Vision Garments Ltd (Extension-2)

10 April 2025

1. ETP BUILDING: This is a 6 storied (B+G+5) reinforced concrete building with underground ETP operation.
2. Connecting Bridge: Single-storied steel structure.

Observation-01: Inadequate number of concrete cylinder test report (ETP Building).

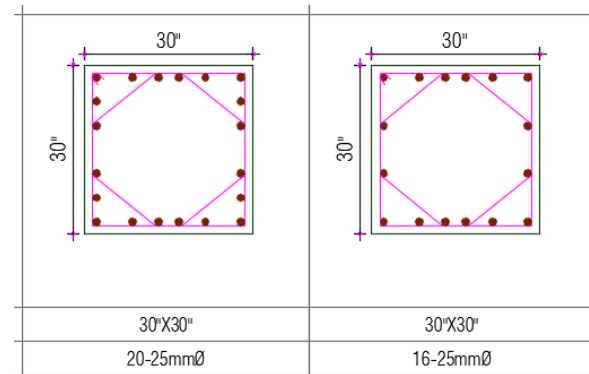
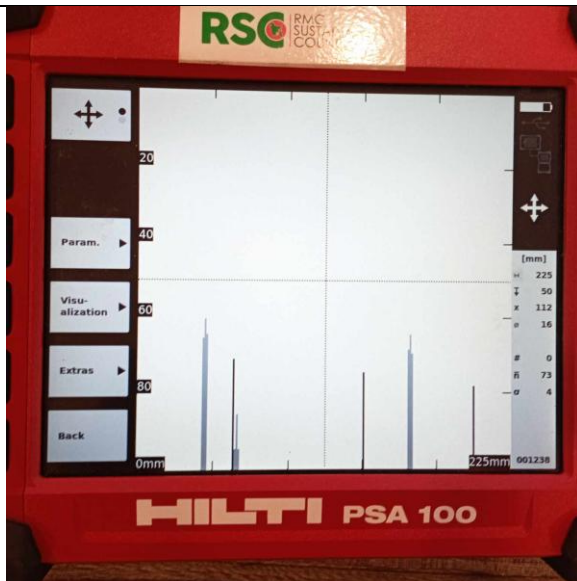
Description: The design strength of concrete is 31 MPa (4500 psi). The building is 6 storied with a basement but at the time of inspection only 3 concrete cylinder test report from column were available; first floor (1) and second floor (2) which doesn't meet the frequency of testing as per BNBC. Also, no test report (column) was available from other floors. The building engineer is required to take adequate numbers of concrete core (minimum 4) from column & floor each to confirm the design concrete strength.

Item No	Observation	Action Plan	Timeline
1.	Inadequate number of concrete cylinder test report (ETP Building).	The building engineer is required to verify in-situ material strength by taking minimum four concrete cores from existing building column & floor each.	within 6 weeks
